HISTORIC AND DESIGN REVIEW COMMISSION

HDRC CASE NO: 2015-284
ADDRESS: 315 LAMAR ST
LEGAL DESCRIPTION: NCB 519 BLK 24 LOT 14
ZONING: R5 H
CITY COUNCIL DIST.: 2
DISTRICT: Dignowity Hill Historic District
APPLICANT: Oscar Santana
OWNER: Corby Walker/CBW Financial Inc
TYPE OF WORK: New construction of two story single family house
REQUEST:

New Residence
for
Santana Remodeling
315 Lamar

ROOF PLAN
A3.1

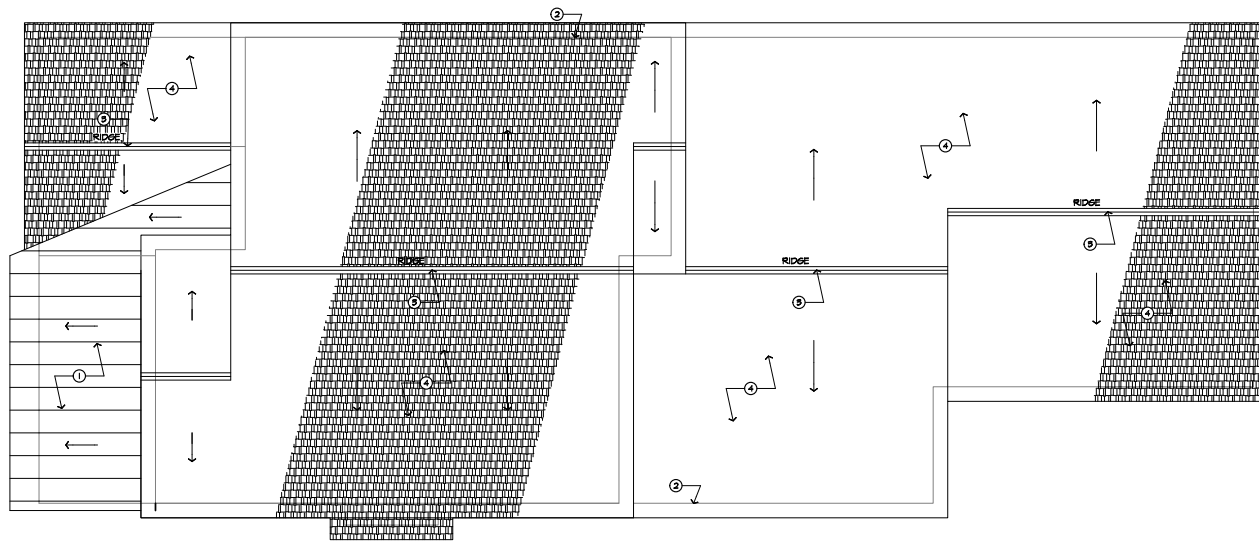
- d. As recommended by the Guidelines for New Construction, new roof forms should be consistent with those predominantly found on the block in pitch, overhangs, and orientation. The proposed roof is consistent with other historic roofs in pitch and orientation. However, the composition of the roof should be simplified to be more consistent with the configuration of historic roofs.

- a. The mass of the two-story portion of the house is set back to better relate to adjacent historic structures
- b. Use of materials is simplified to be more consistent throughout
- c. Fenestration pattern along the sides and rear is revised to be more consistent with historic facades
- d. Architectural details are simplified
- e. Garage is detached to be consistent with historic garage placement
- f. Information on landscaping, fencing and mechanical system placement is submitted for review
- g. Specifications for windows and doors are submitted for review
